Re: **Petition No. 1178 – Fusion Solar Center, LLC – Environmental Monitoring Daily Site Observation Form Report Nos. 11 and 12**

ENVIRONMENTAL MONITORING
DAILY SITE OBSERVATION FORM

Report No. 11

Project: DEPCOM Power, Fusion Solar Center
Address: Potash Hill Road, Sprague, Connecticut

SKETCH MAP - 6/7/17

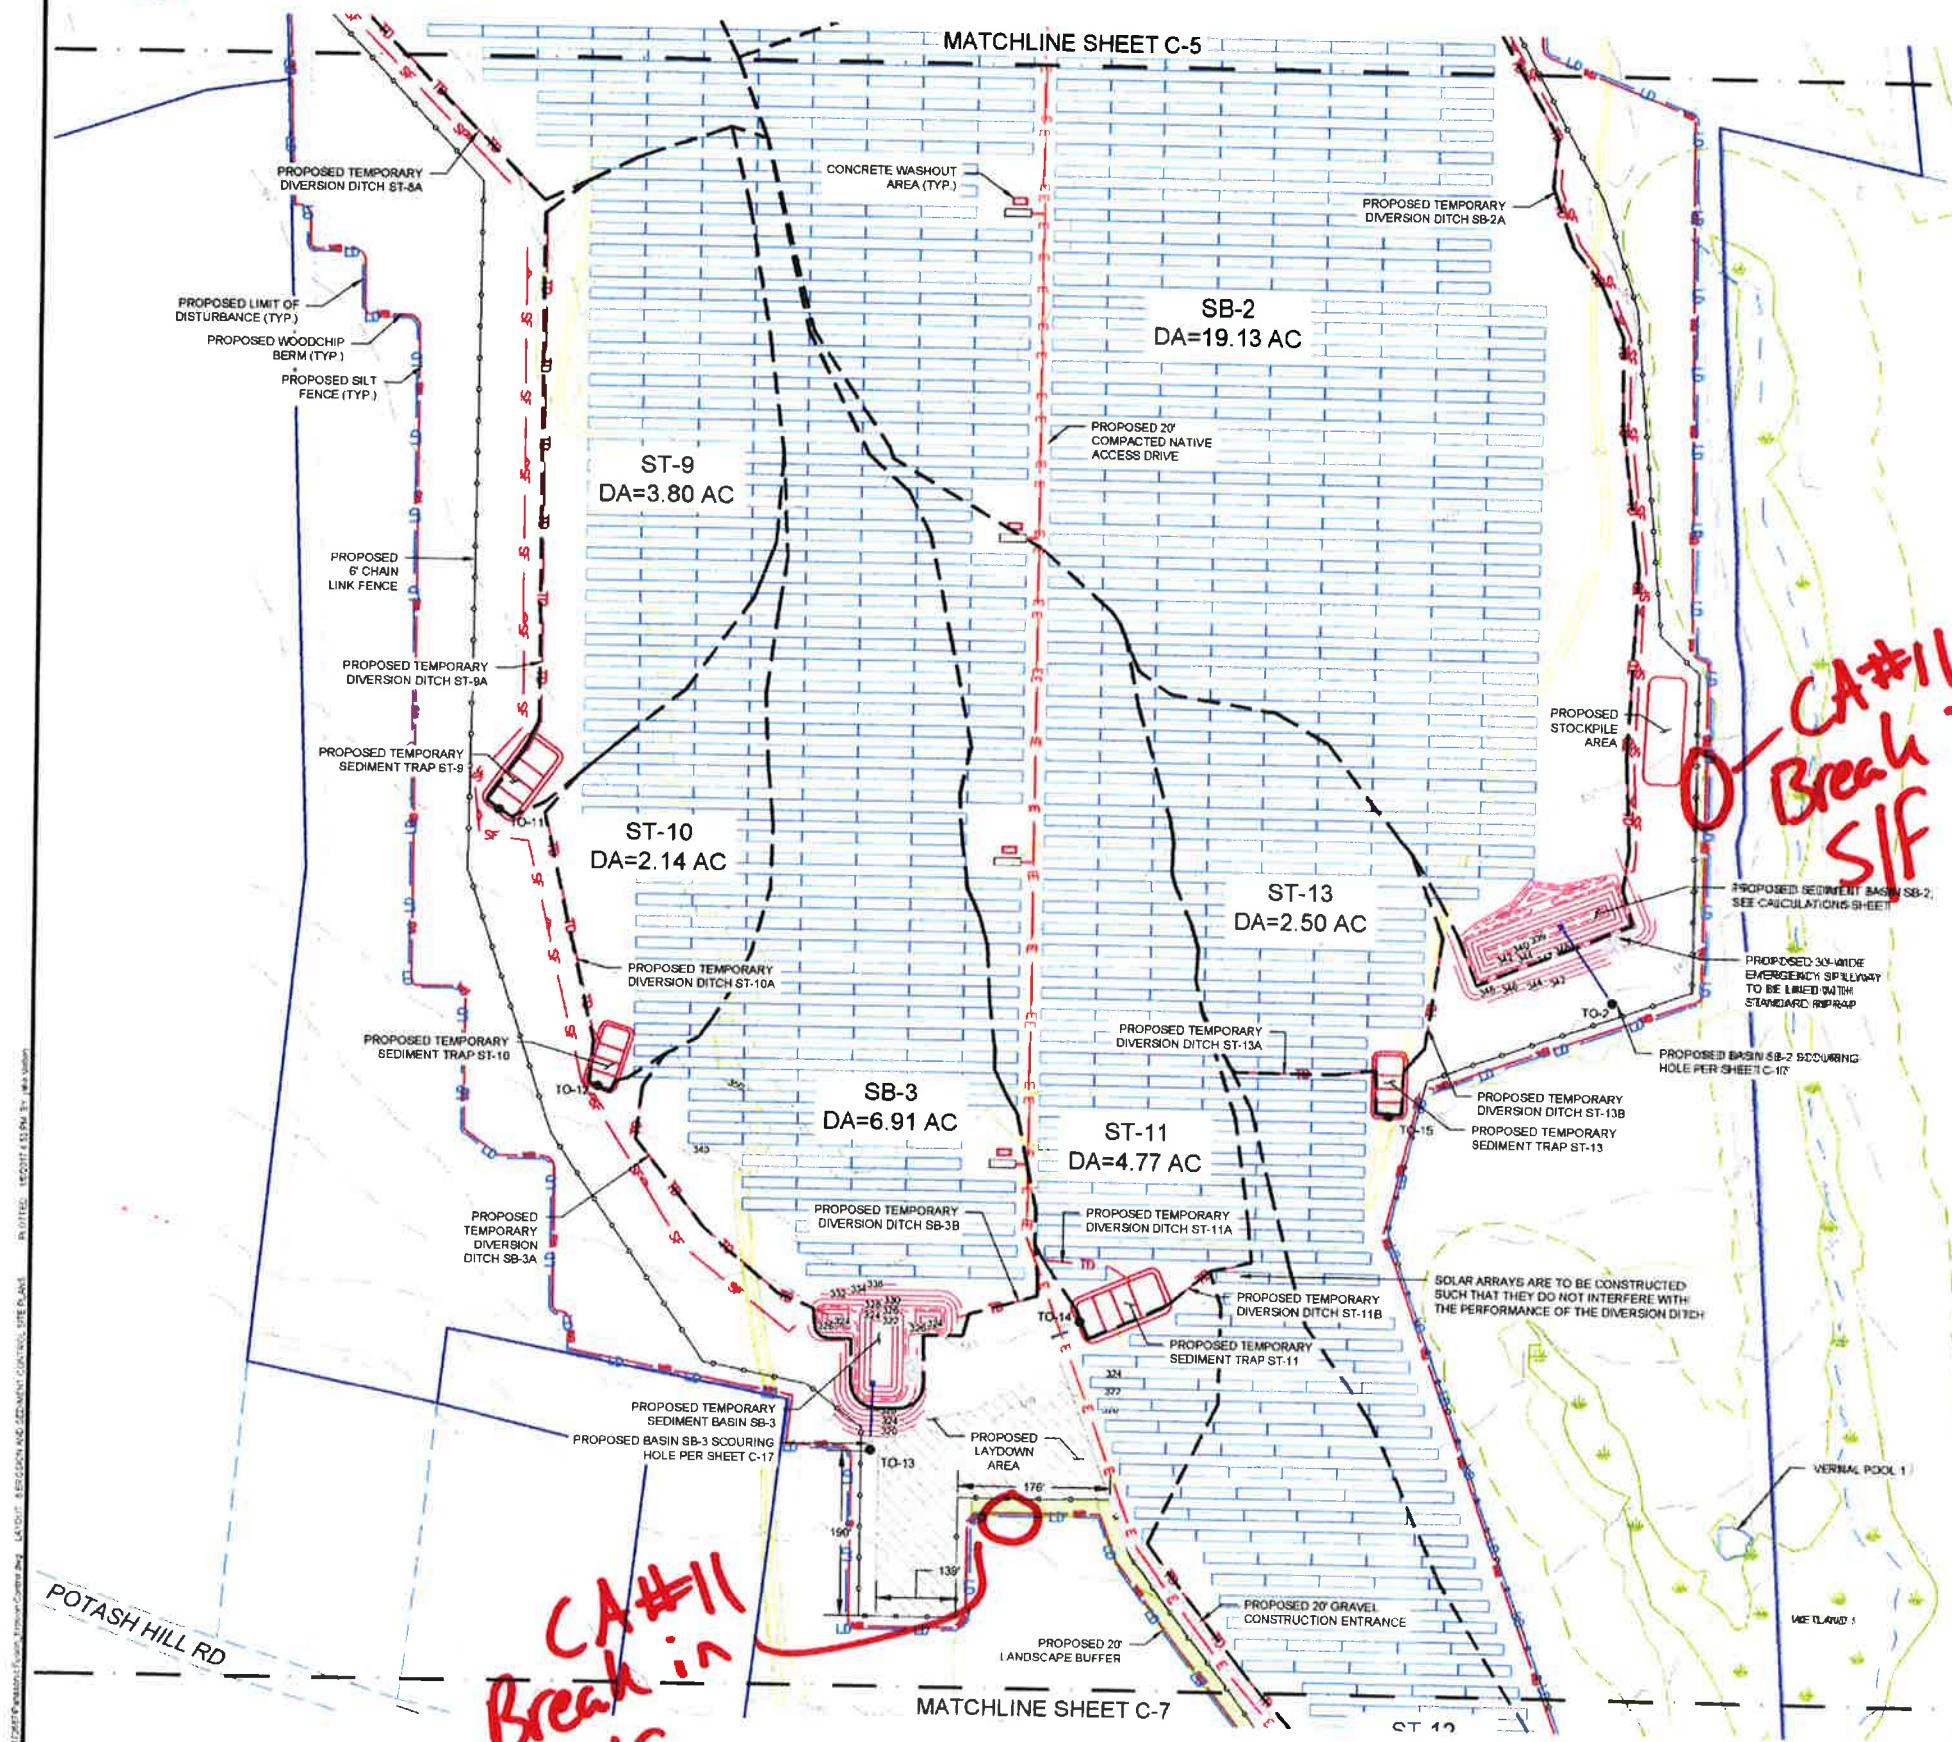
CA#11
Re

Hand-drawn map showing the layout of erosion and sediment control measures. The map includes a vertical scale bar for 0 to 400 feet and a horizontal scale bar for 0 to 1000 feet. Red handwritten notes on the left side of the map read: 'Sediment build up front of SRF - clear out repair', 'CAI Break in SRF', and 'CAI Break in SRF'.

✓ CA #8- large amount of sediment build-up; S/F install incomplete

CA -
Break SI

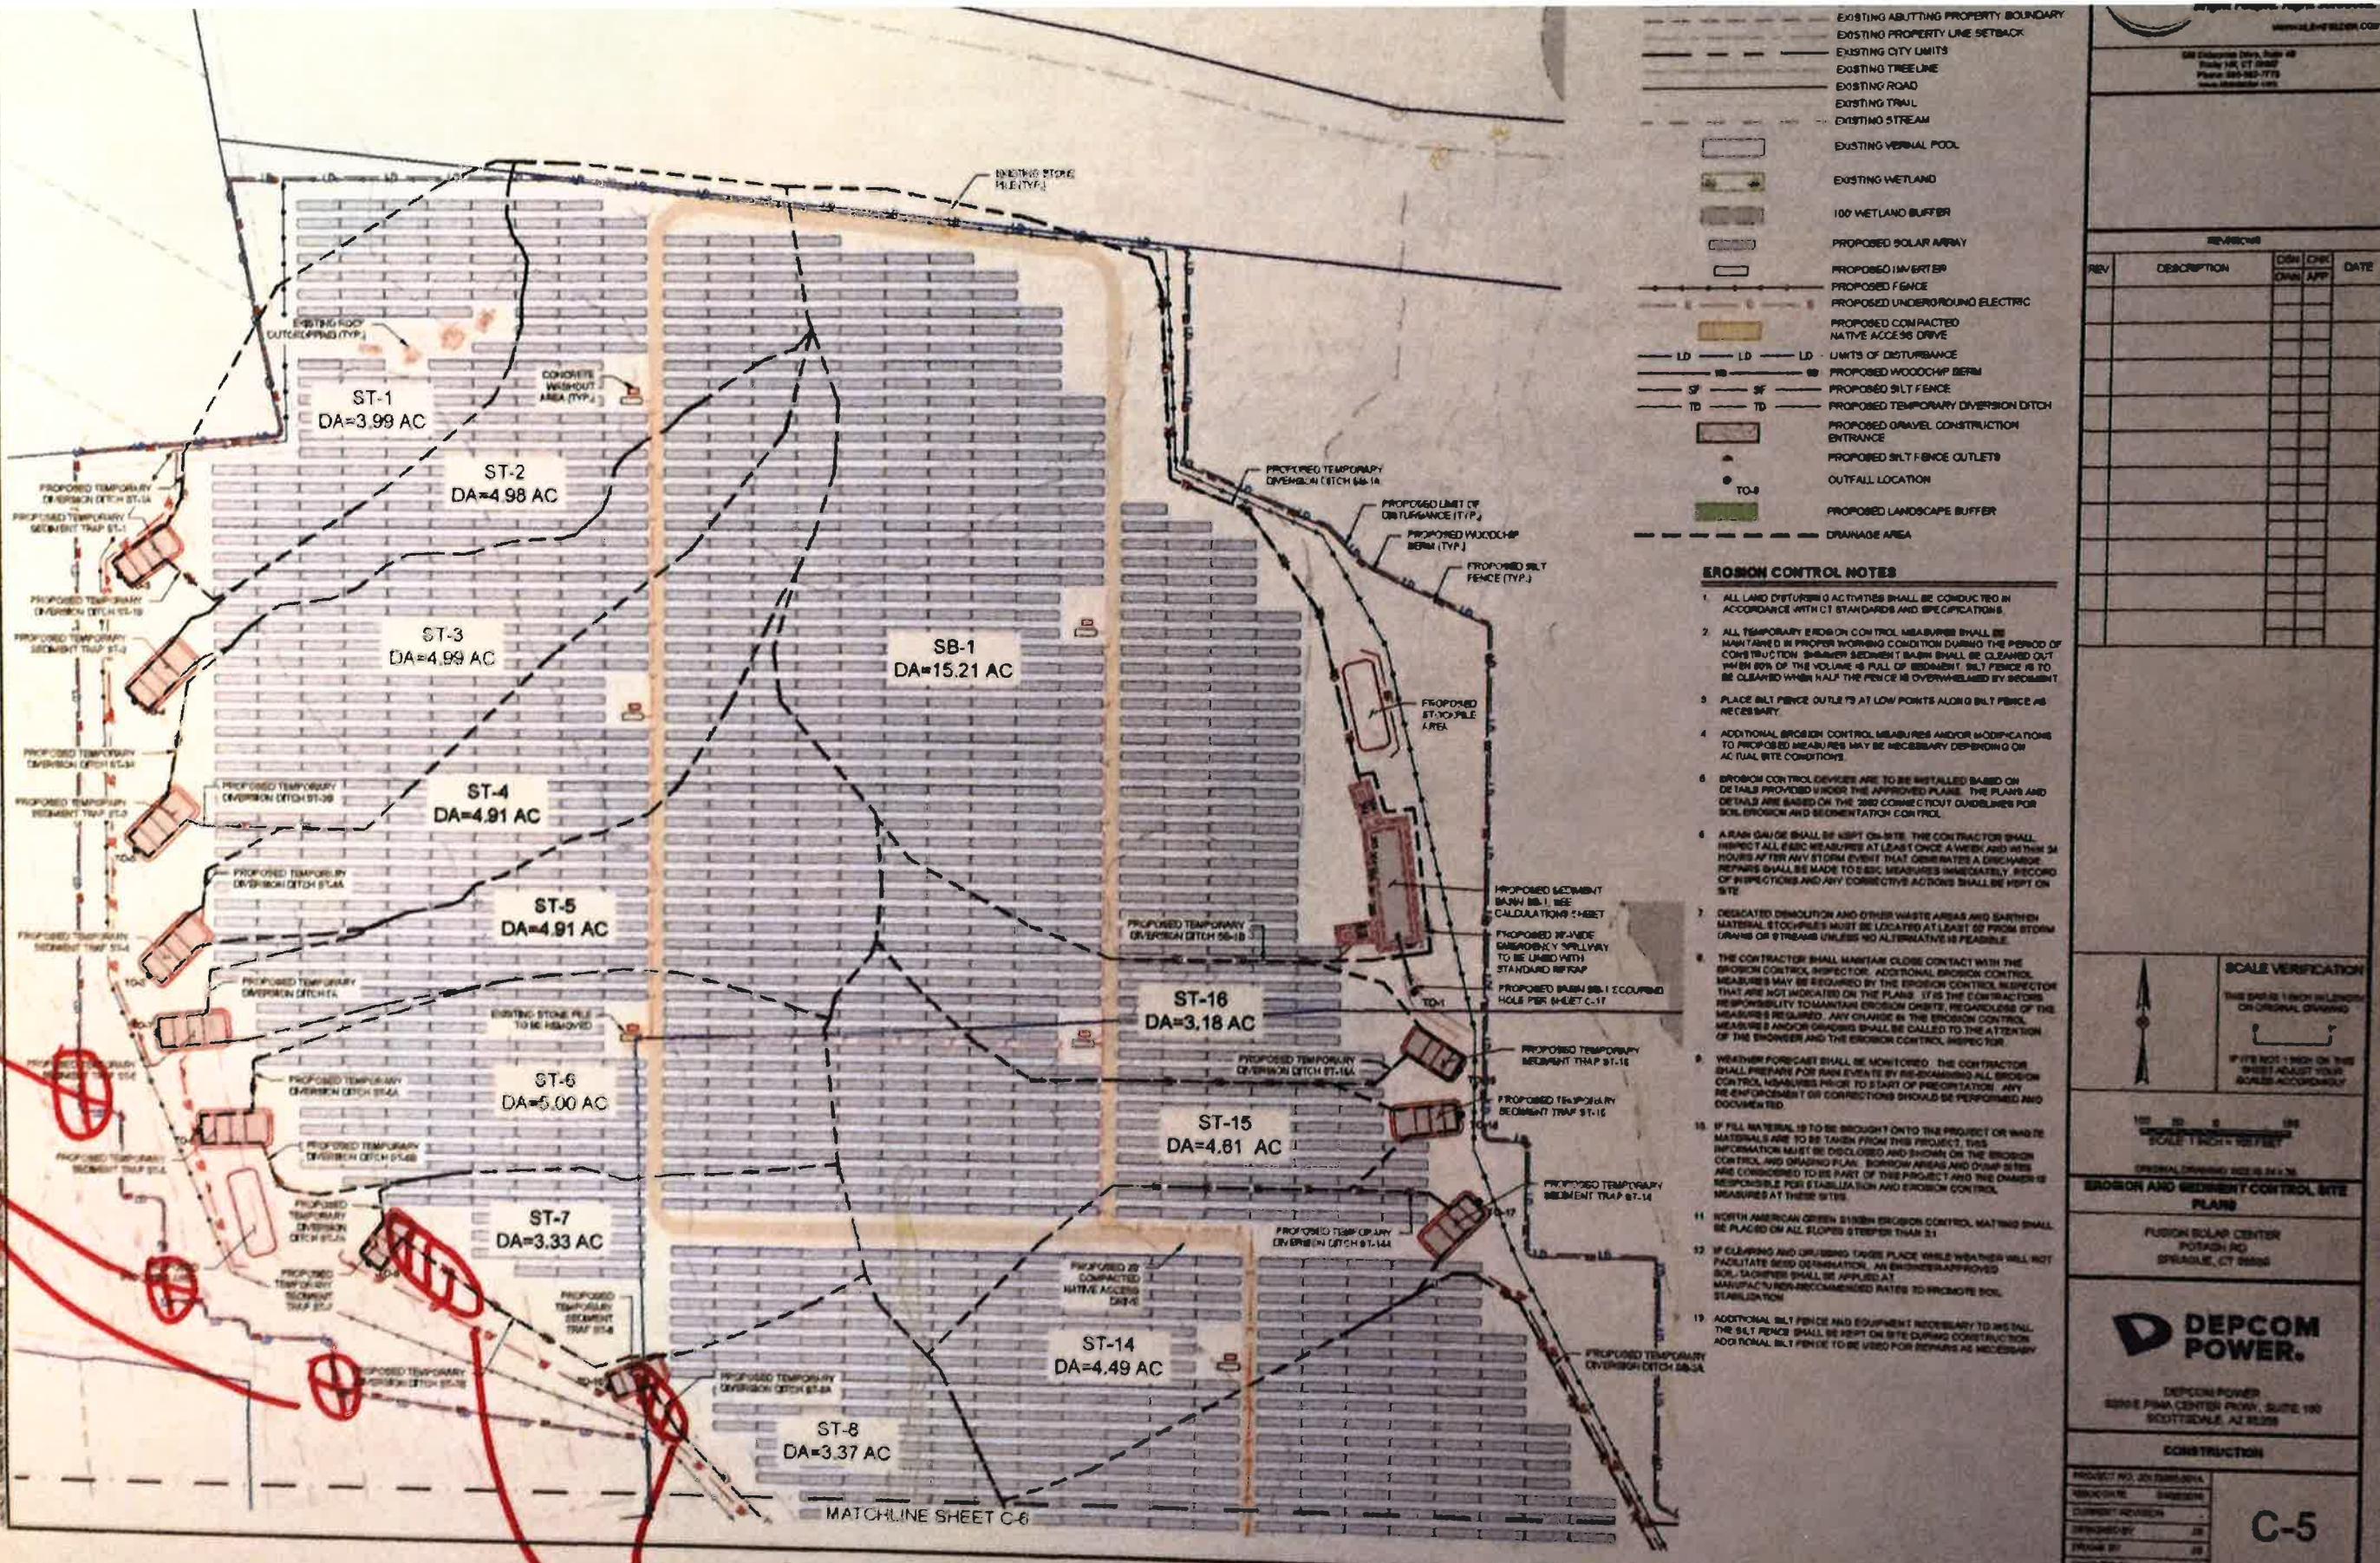
CA 45

Note: Diversion ditch drainage not entirely
draining to basin - Consider regrading
